**Report: TAB REPORT**  
**Function: Test, Adjust, & Balance**  
**Date: 02/06/2026**  
**Completed By: National TAB**

**PROJECT**  
**02-02-26 CULVERS - CHARLOTTE, NC**

Project: 02-02-26 CULVERS - CHARLOTTE, NC

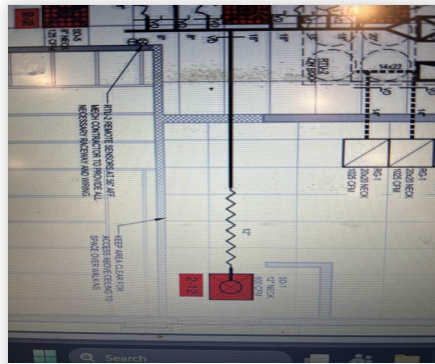
**Issue Name :** Damper inaccessible  
**Description :** Damper inaccessible, supply drop is laying on ceiling pad, unable moved. diffuser is taking to the air from neighboring diffusers.  
**Created By :** National TAB                      **Assigned To :** National TAB - Dan Hertenstein  
**Status :** Open  
**Priority :** Medium                                      **Asset Tag :** SGRD10  
**Originated Date :** 02/05/2026 - Jearod Ferrette - National TAB

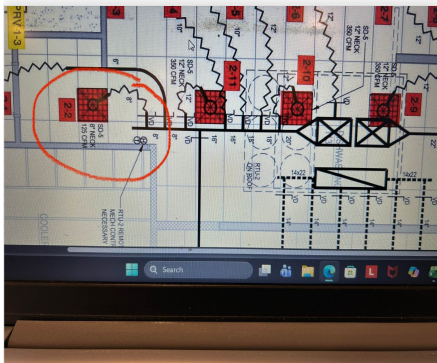
**Issue Name :** Damper not installed SRGD12  
**Description :** SGRD 2-12 damper not installed.  
**Created By :** National TAB                      **Assigned To :** National TAB - Dan Hertenstein  
**Status :** Open  
**Priority :** Medium                                      **Asset Tag :** SGRD12  
**Originated Date :** 02/05/2026 - Jearod Ferrette - National TAB

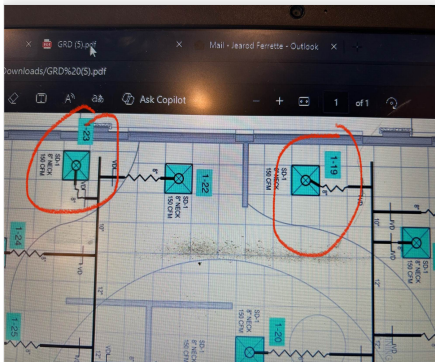
**Issue Name :** Diffuser not installed SGRD 2  
**Description :** On RTU 2 diffuser 2-2 wasn't installed due to spacing issue. Duct was capped, and the air will be equally balanced to the back 3 diffuser of the cook line.  
**Created By :** National TAB                      **Assigned To :** National TAB - Dan Hertenstein  
**Status :** Open  
**Priority :** Medium                                      **Asset Tag :** SGRD2  
**Originated Date :** 02/04/2026 - Jearod Ferrette - National TAB

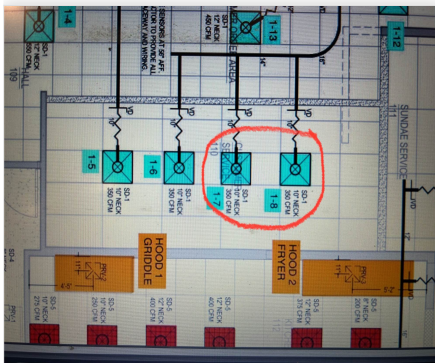
**Issue Name :** Missing dampers on RTU 1  
**Description :** Missing dampers on SGRD 19/23.  
**Created By :** National TAB                      **Assigned To :** National TAB - Dan Hertenstein  
**Status :** Open  
**Priority :** Medium                                      **Asset Tag :** RTU1  
**Originated Date :** 02/05/2026 - Jearod Ferrette - National TAB

**Issue Name :** RTU-2 ductwork undersized

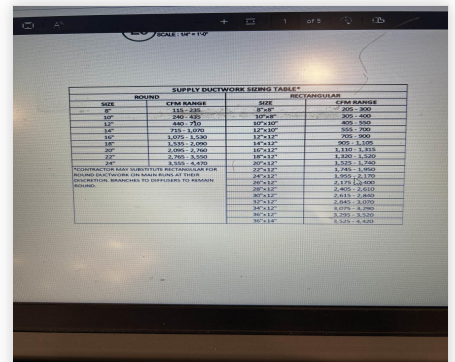
**Description :** RTU 2 is currently at 88% of design total flow. The ductwork from the unit was installed horizontally, this restricts the unit. On the MSET rooftop drawings refers to a note (M101) about proper ductwork size. Currently the supply ductwork 25x14 and also insulated inside. Supply pressure is at 1.50", the unit was at max amps 26.9a @61.5hz.

- **02/04/2026 National TAB - Jearod Ferrette**
  - The unit was slowed down by 2hz, to bring down the amps. Per the mechanical there is an email chain from Captive Air. The engineers wanted the unit to be ducted horizontally. This unit will be proportionally balance.

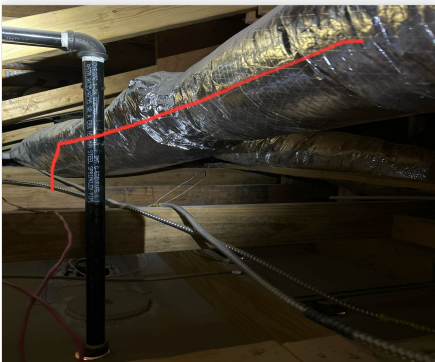
**Issue Name :** RTU-2 return ductwork damaged  
**Description :** On RTU-2 return duct damaged  
**Created By :** National TAB                      **Assigned To :** National TAB - Dan Hertenstein  
**Status :** Open  
**Priority :** High                                      **Asset Tag :** RTU2  
**Originated Date :** 02/04/2026 - Jearod Ferrette - National TAB

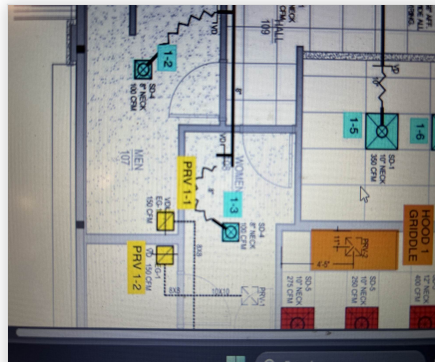
**Issue Name :** Women's RR damper inaccessible  
**Description :** Women's restroom, damper inaccessible above hard ceiling.  
**Created By :** National TAB                      **Assigned To :** National TAB - Dan Hertenstein  
**Status :** Open  
**Priority :** Medium                                      **Asset Tag :** SGRD3  
**Originated Date :** 02/05/2026 - Jearod Ferrette - National TAB
